Subject: Cascade River Ranch

Our team has reviewed the City comments dated May 3, 2019, and offer the following responses:

Re: Response to Cascade River Ranch City Comments dated May 3, 2019

CLIENT:
Cascade River Ranch
Diamond 4-plex
Cascade, ID

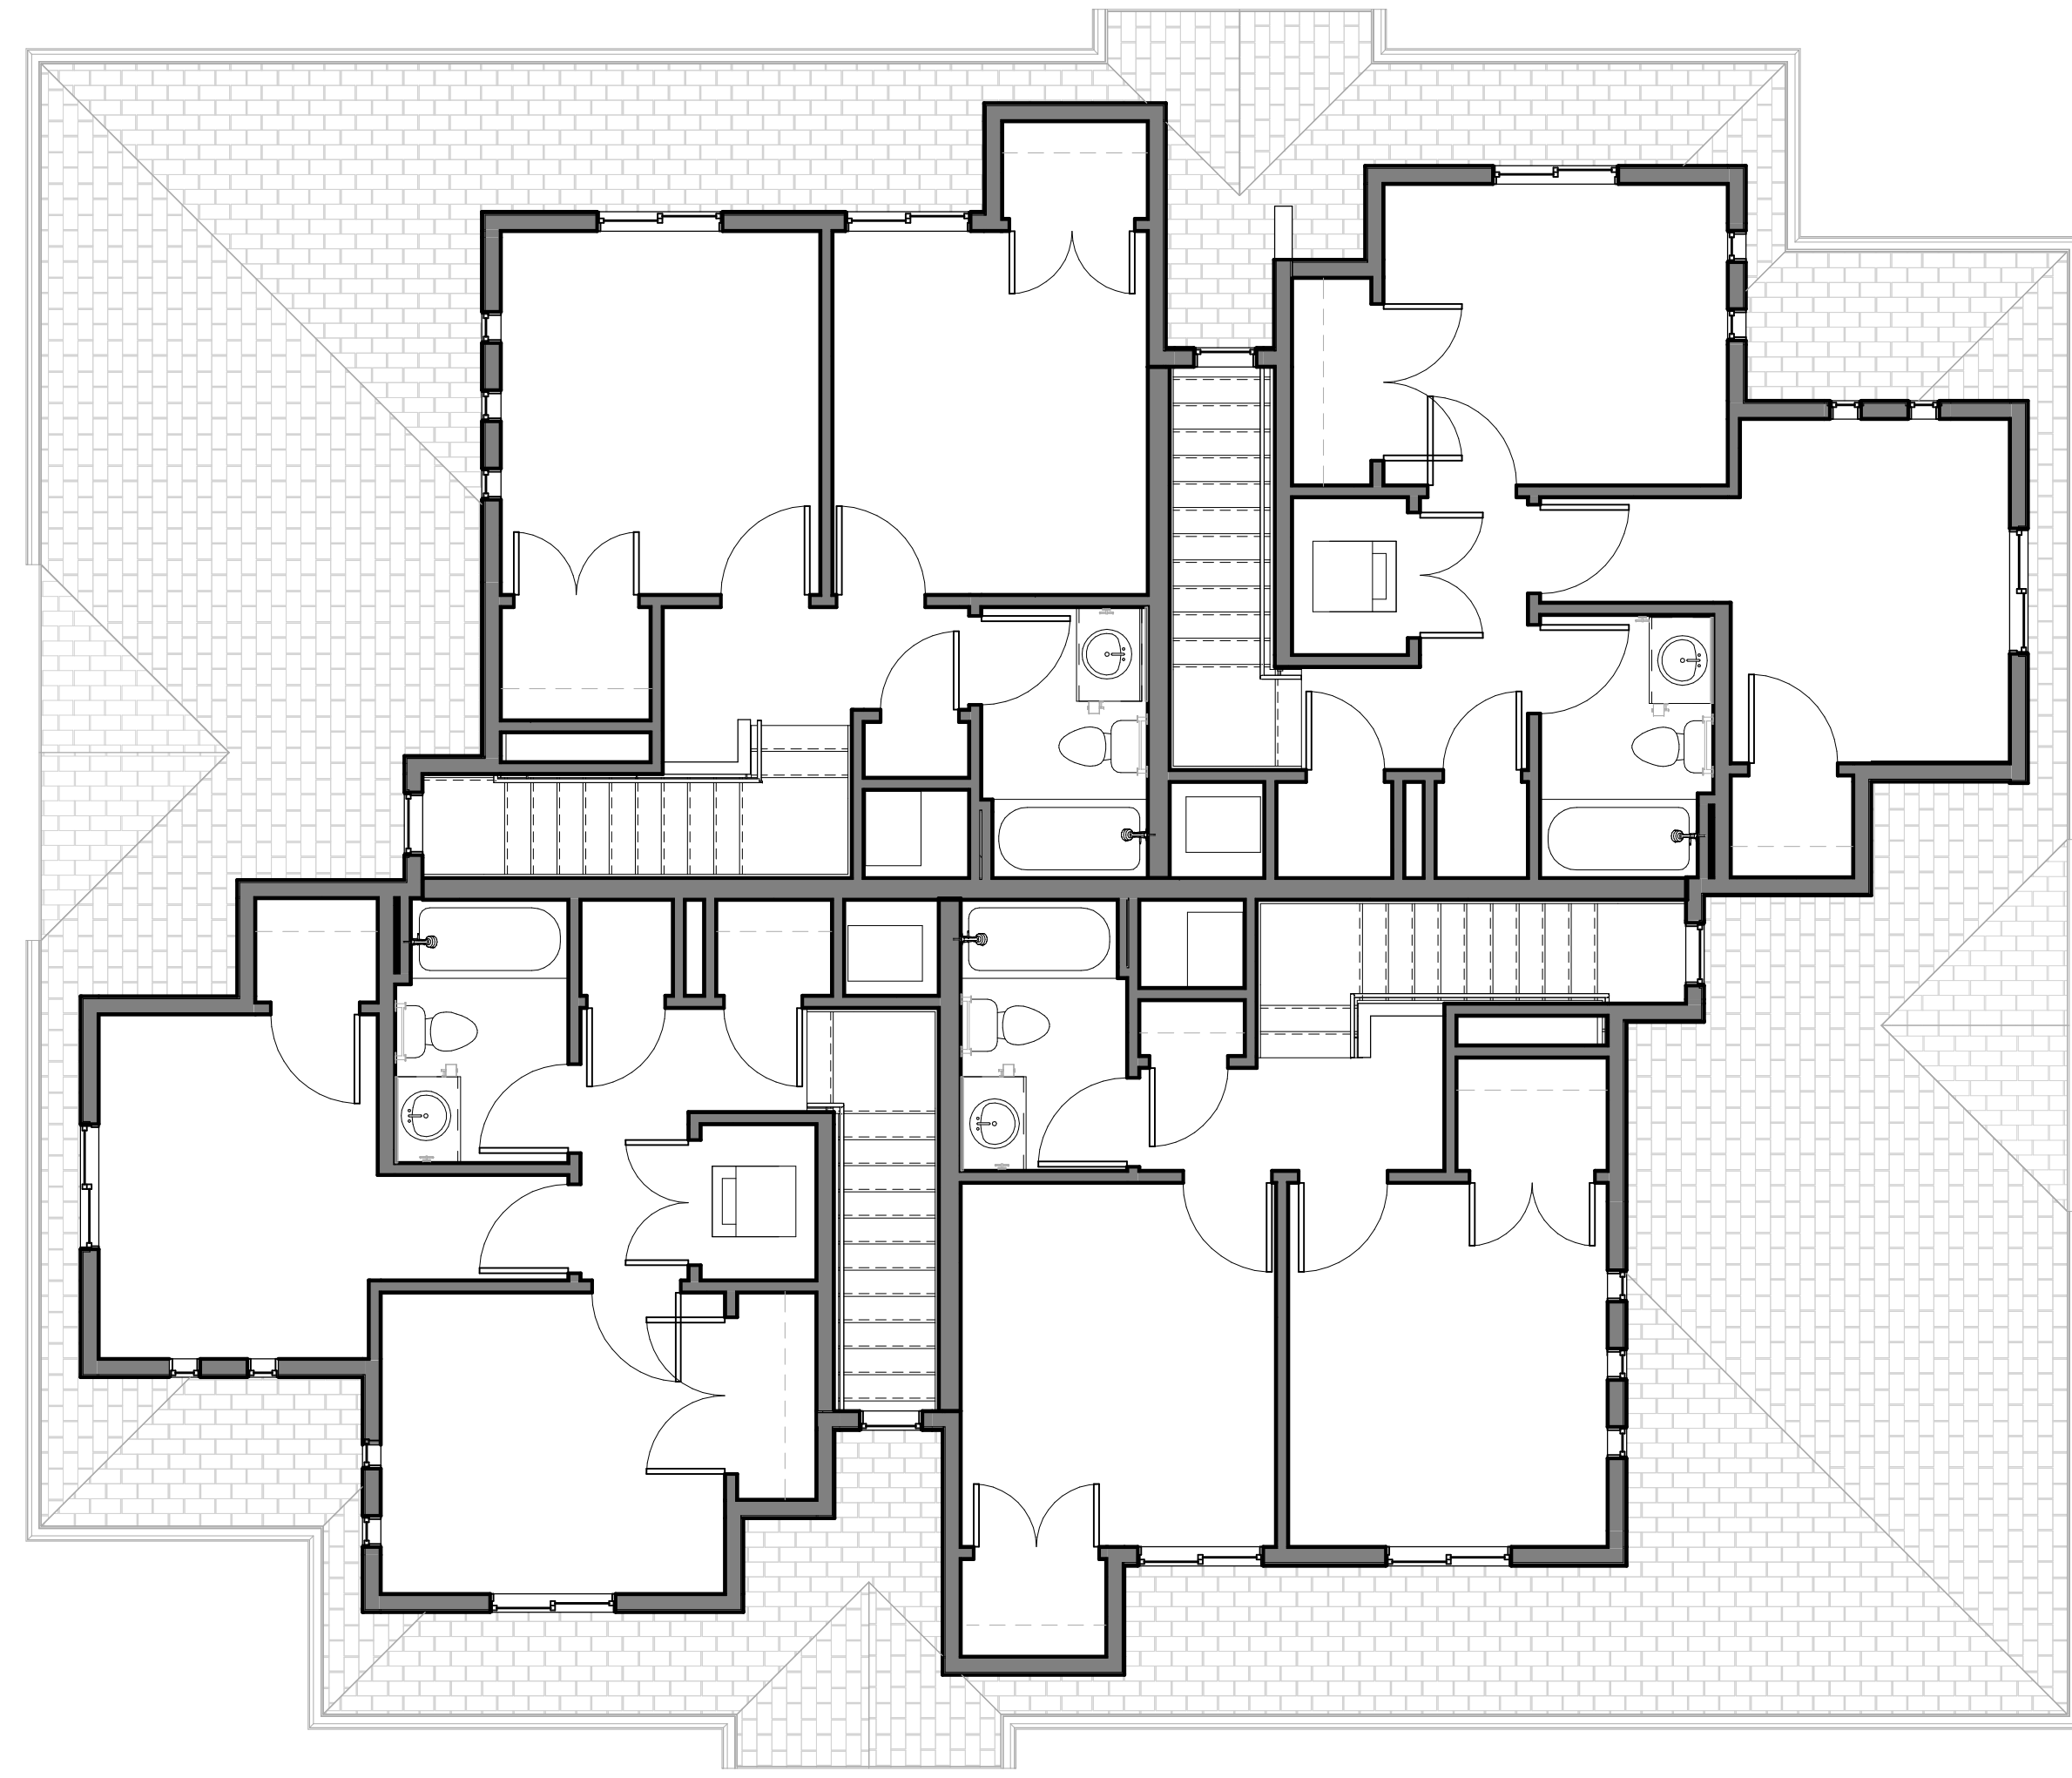
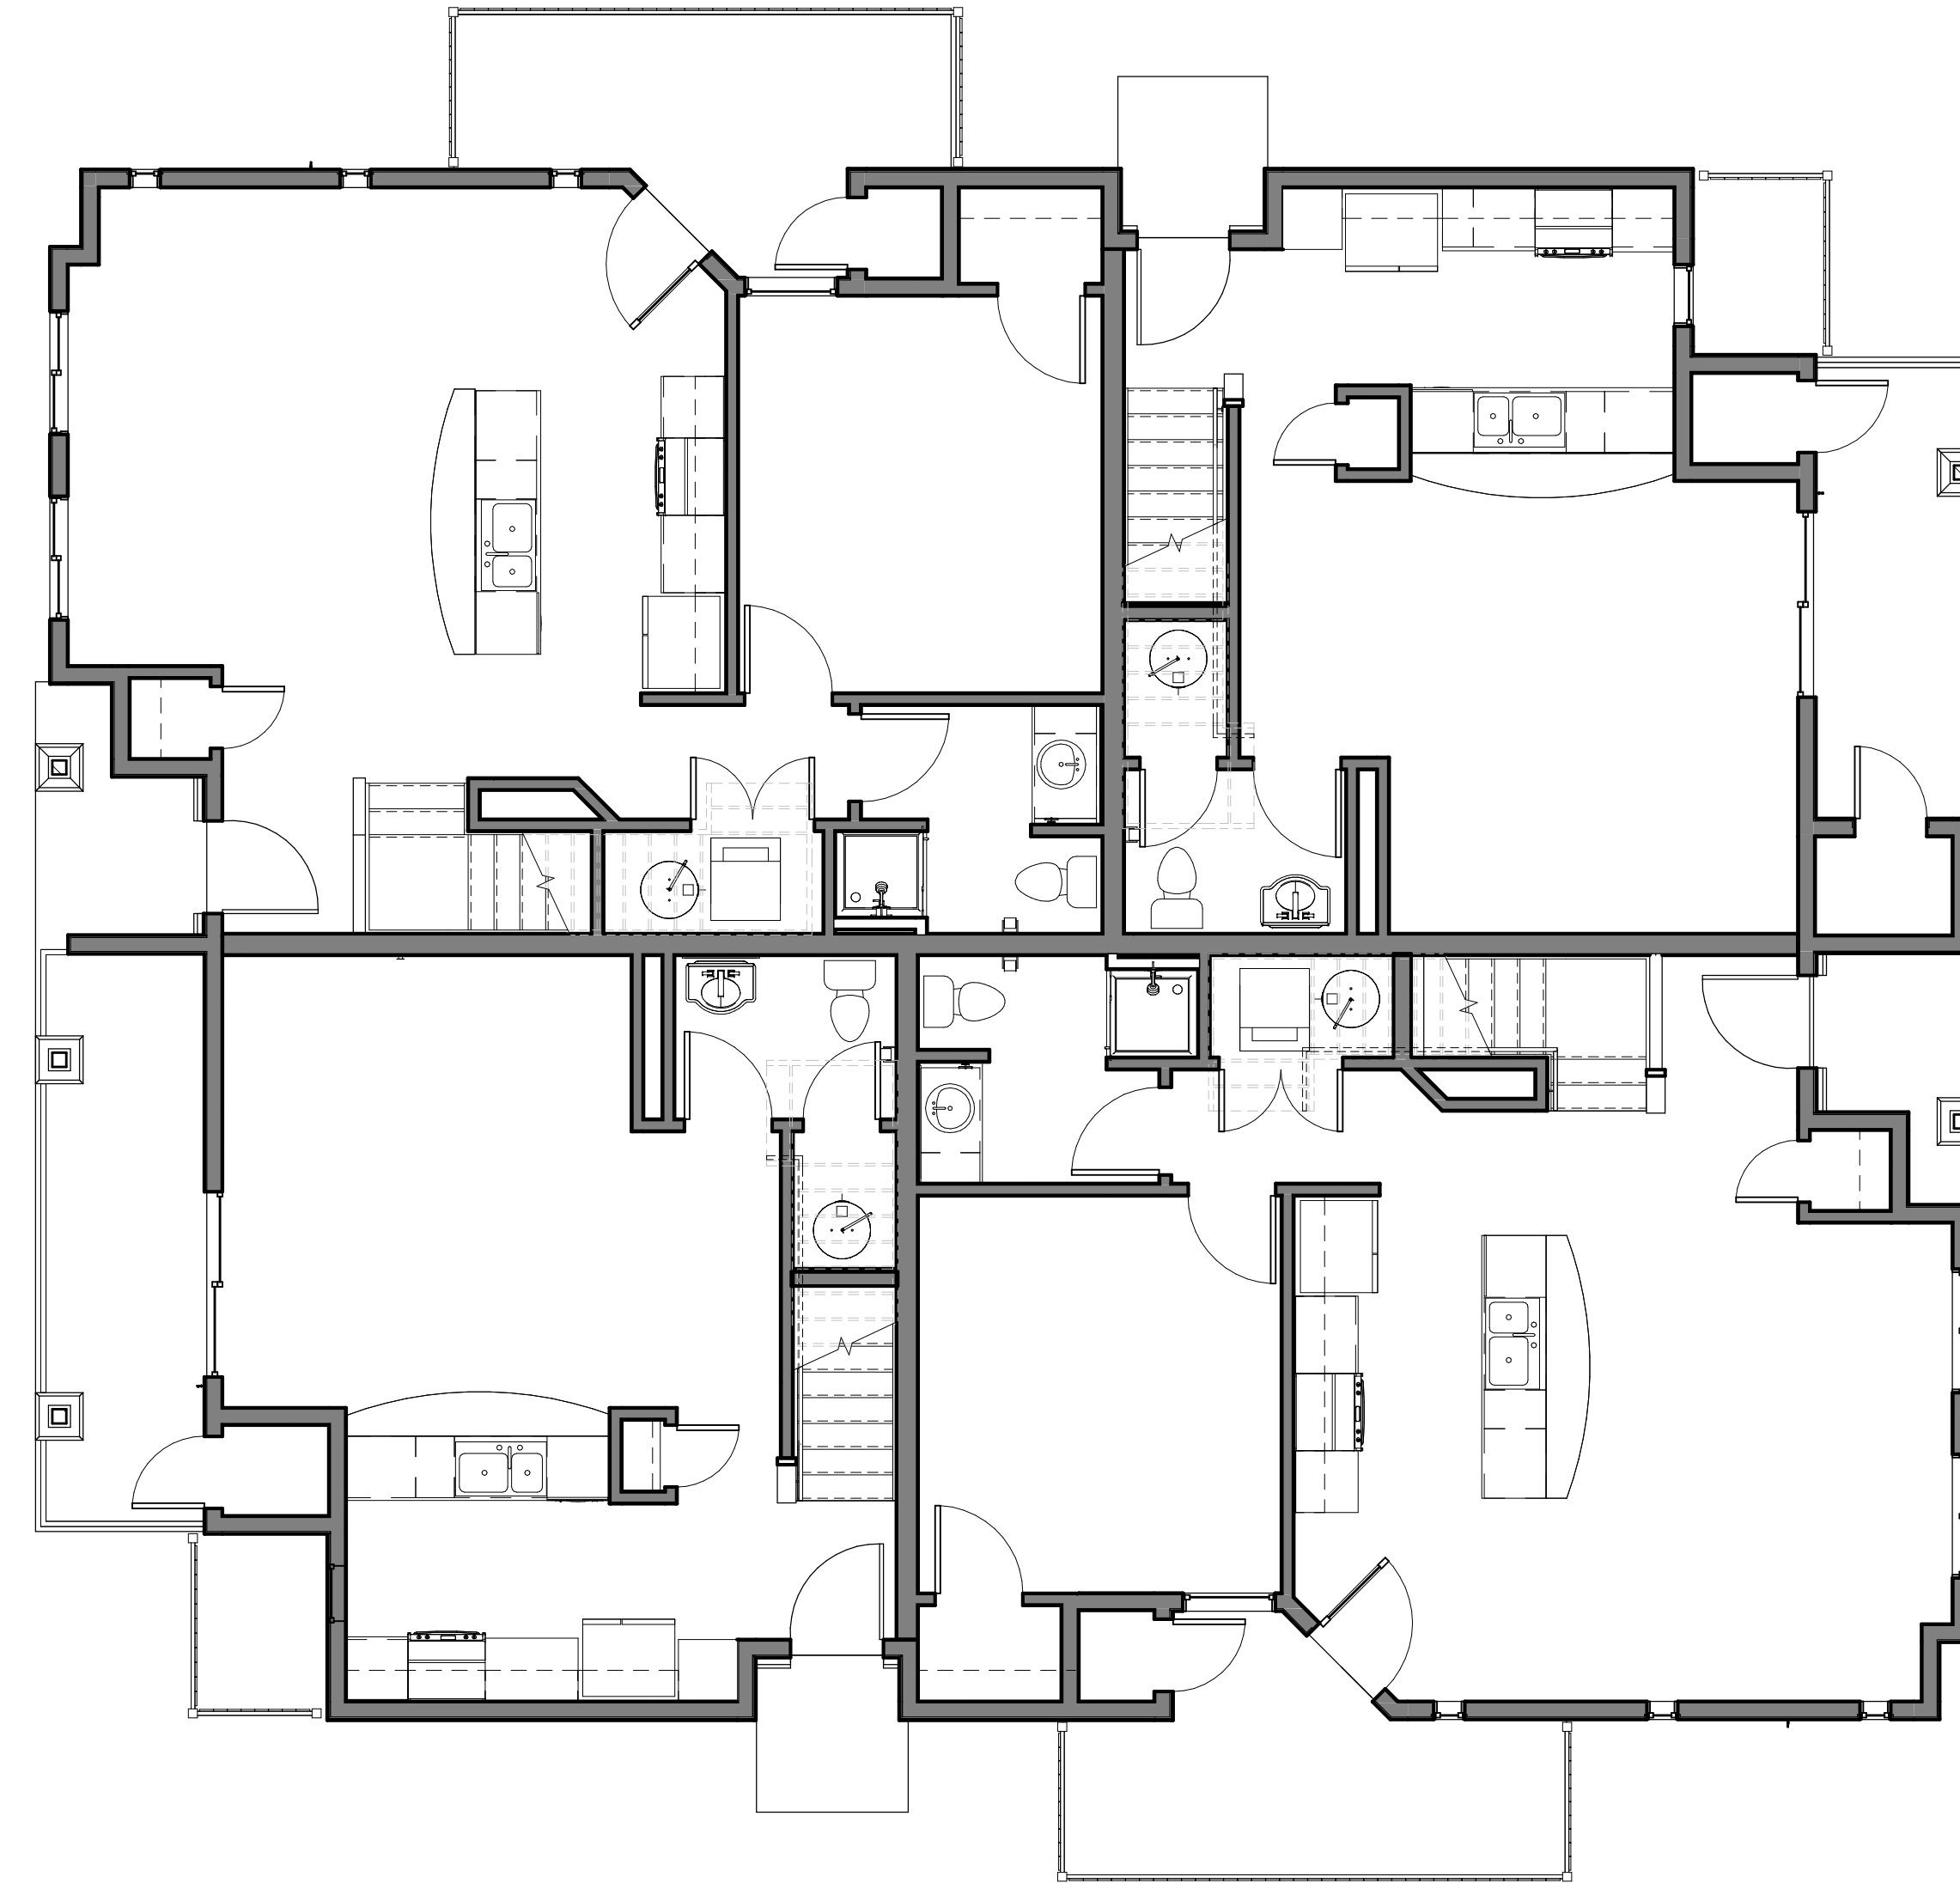
3. Provided are architectural samples as requested for the multifamily uses and commercial uses. The commercial uses will not be constructed for a long time out so we have not done a lot of work with that architectural design. A separate application could be conditioned on those commercial pads at the time those uses come into the City. A detail of the fence is on the landscape plan, and we have provided a typical detail of the trash enclosure and indicated a location on the map.
